Service Letter

Subject: Bell 427 Air Conditioner Blower Motor Connector Upgrade.

Applicability: Bell Helicopter Model 427 equipped with the Air Comm Corporation 427EC-200-1 thru -4 air conditioning systems

Reference: ACC Service Bulletin SB 427-110414

Figure 1 Aft Evaporator Blower Assembly (blower configuration may differ slightly. Connector is used on all 427 aft evaporators)

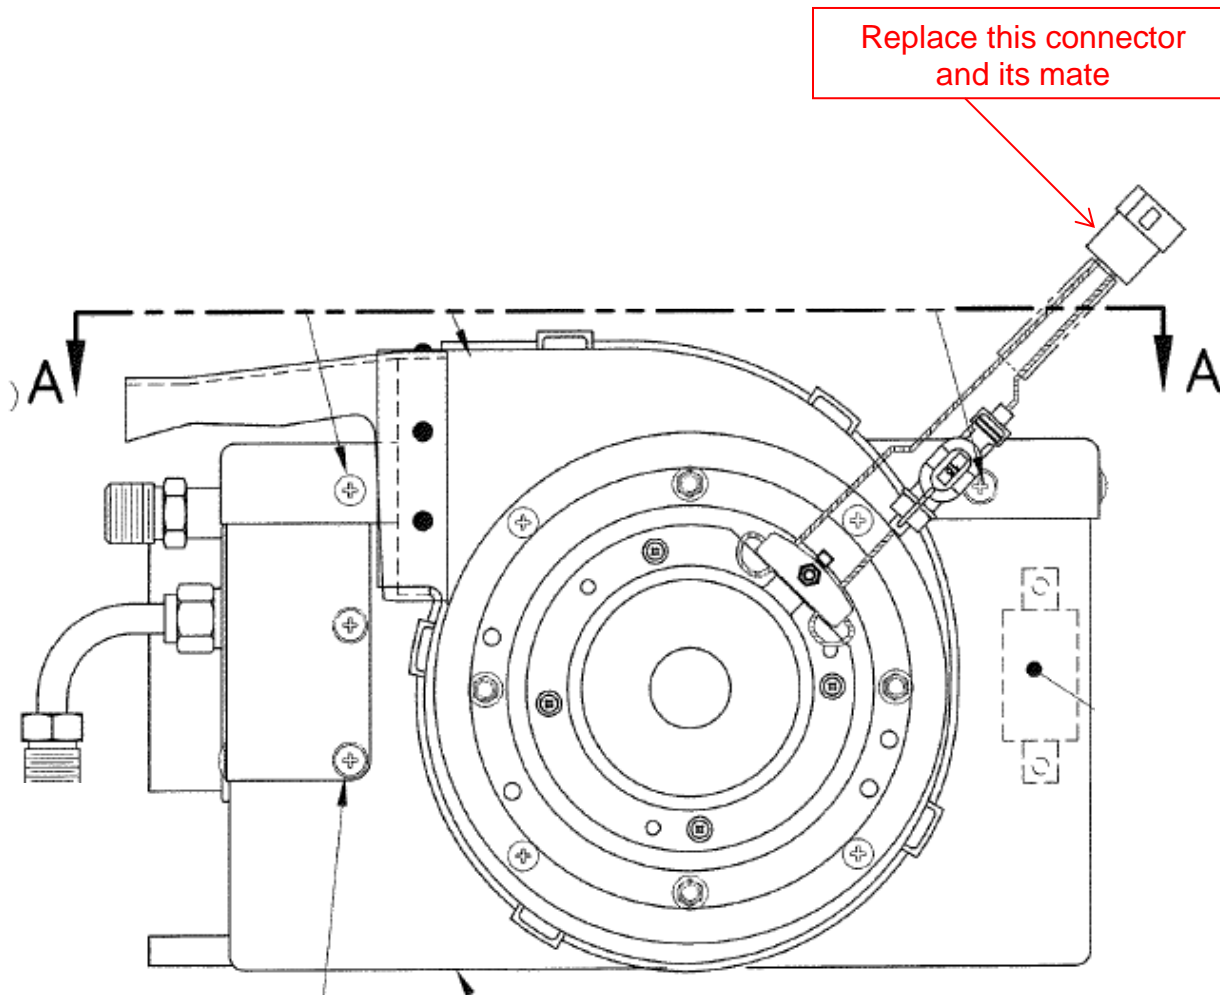
1. Access the aft evaporator assembly, located on the left side above the aft baggage compartment.
2. Locate the 2 pin connector (see Figure 1) and mark the white wires "Red" and "Black" as appropriate. It may be necessary to remove a portion of the heat shrink covering on the harness.
3. Cut the wires on the back side of the connector shown in Figure 1 and its mate. Remove minimal wire length. Remove and discard the connectors w/pins & sockets.

Install pins, sockets, plugs, and receptacles onto free ends of wires.

Crimp Molex pins using Molex Corporation Tool #0638111000 (Available thru Molex USA 1-800-786-6539) or equivalent wire terminal crimping tool for Molex 1189, 1190 series terminals (2.36mm / .093" dia).

Figure 2. Condenser Blower 427 AC systems

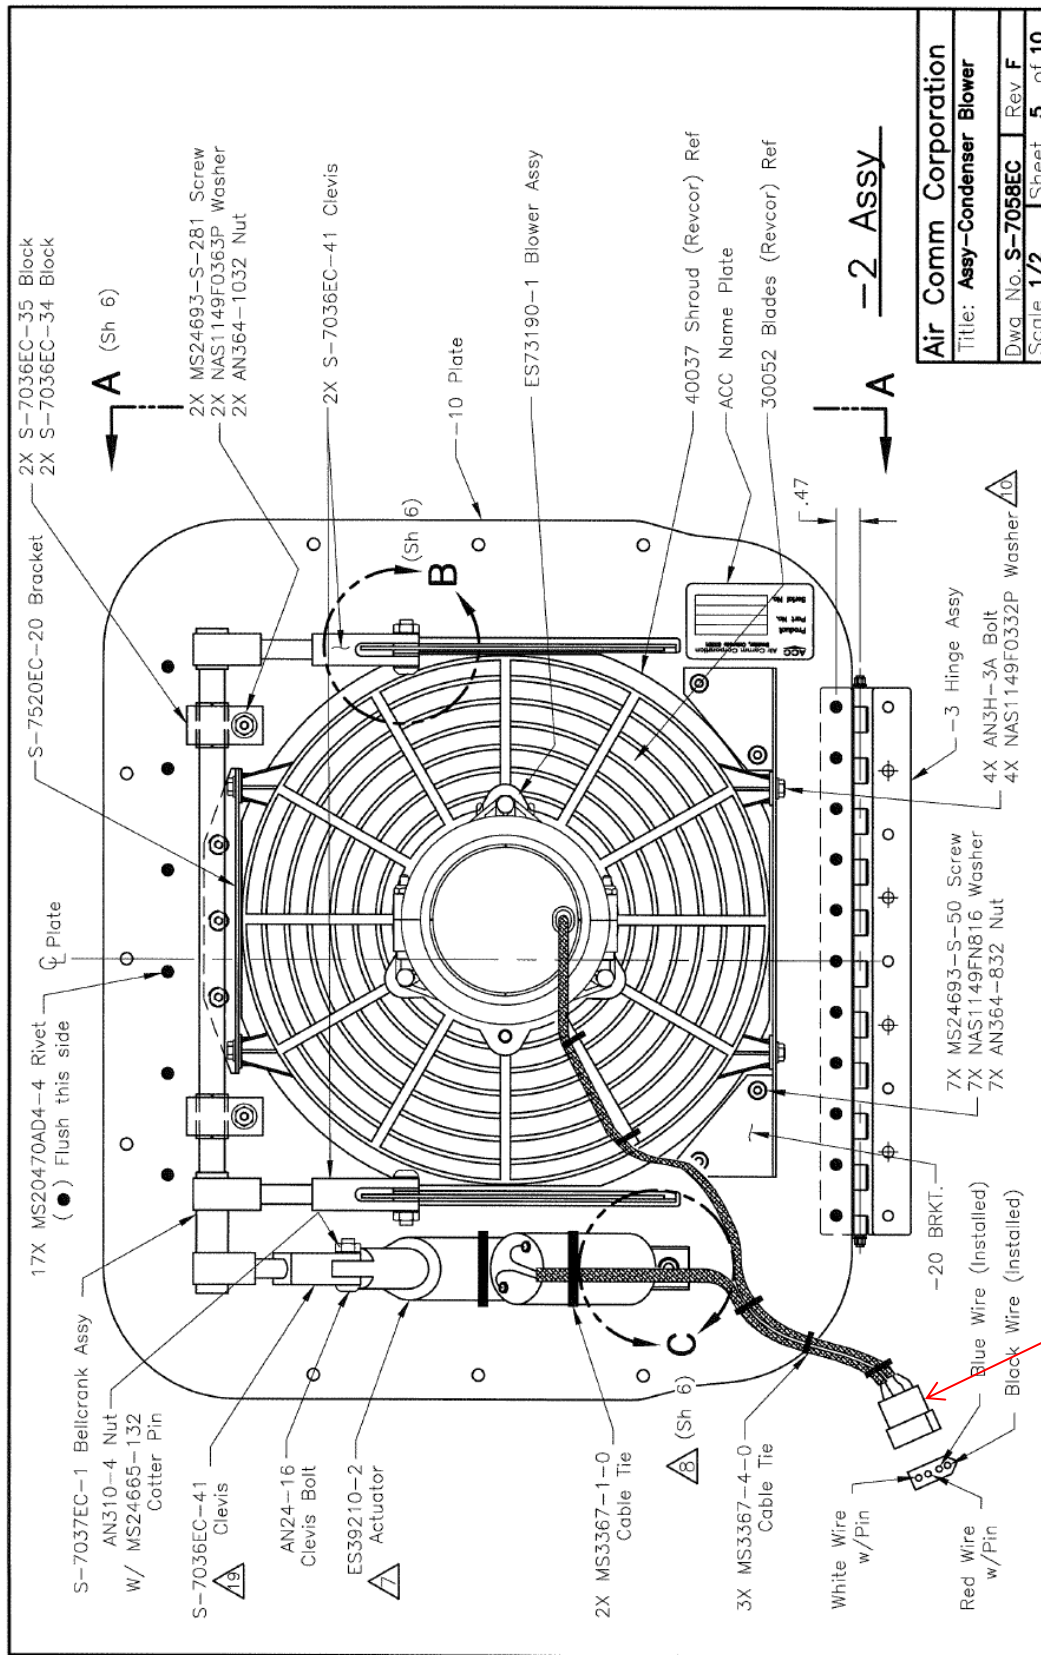
1. Access the condenser assembly, located below the aft cargo compartment. See Figure 2.
2. Locate the 4 pin connector on the blower harness.
3. Identify the wires and remove both the plug and receptacle.

Replace this connector and its mate

Install the supplied pins, sockets, plugs, and receptacles onto free ends of wires.
Crimp Molex pins per instructions on sheet 3.
